Shenzhen Divoom Technology Co., LTD.

Declaration of Product Modifications

This is to request a Class II permissive change for FCC ID: A8I-DIPOW-35 originally granted on 12/26/2024.

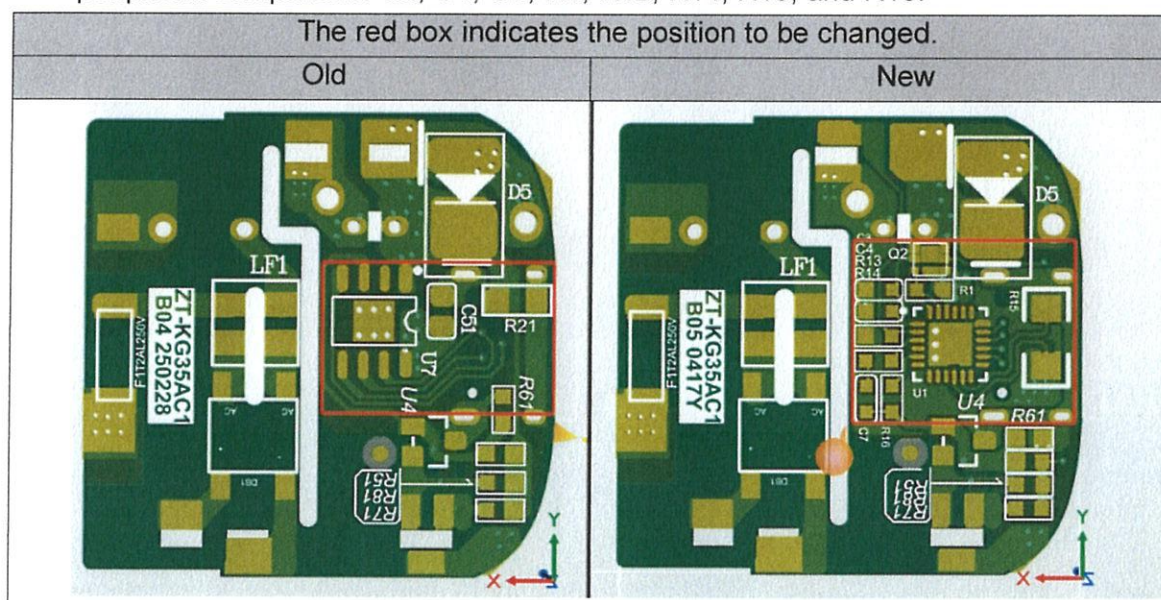
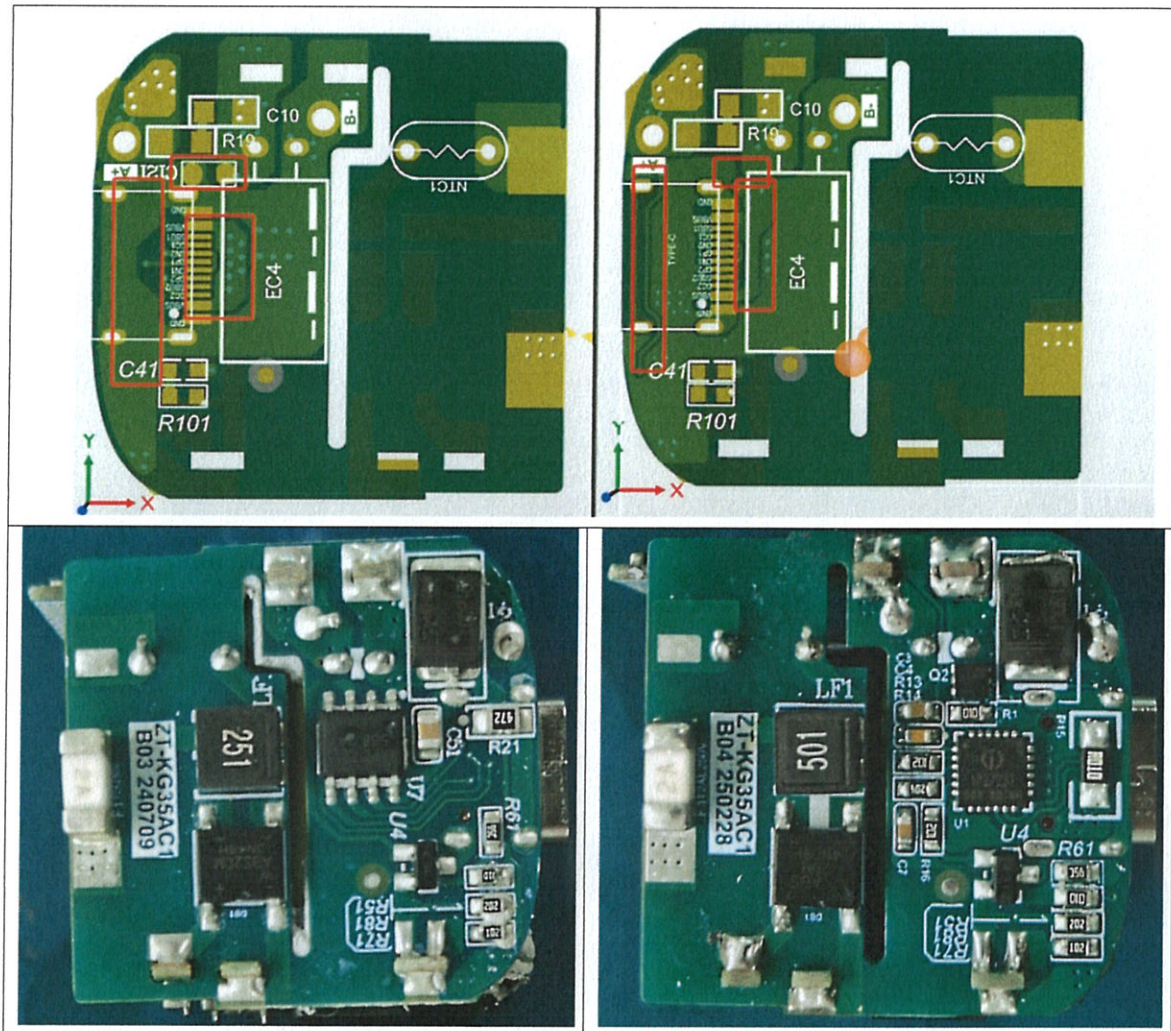
1. Change a few parts of the main board.
2. Change the company address of Applicant.

The changes to the motherboard are as follows:

Replace the protocol chip from XPD719 to IP2723 to meet the power requirements of the display.

Replace XPD719 and its peripheral components C51 and R21 with IP2723 and its peripheral components C3, C4, C7, R1, R13, R14, R15, and R16.
